Addendum (25-10865-30)

To : Users of Manuals for VA-503+ (part no: 25-10865-21 and 25-10865-01)

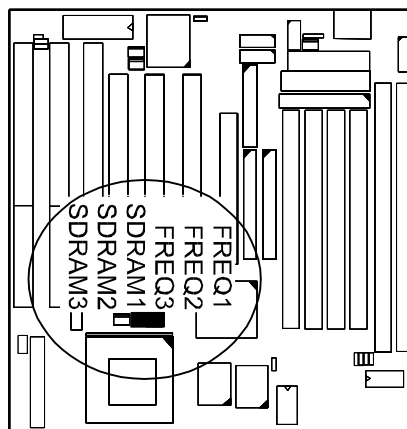
1. Page 8, 15, 18-

The jumpers' location of SDRAM1, 2, 3 and FREQ1, 2, 3 should be :
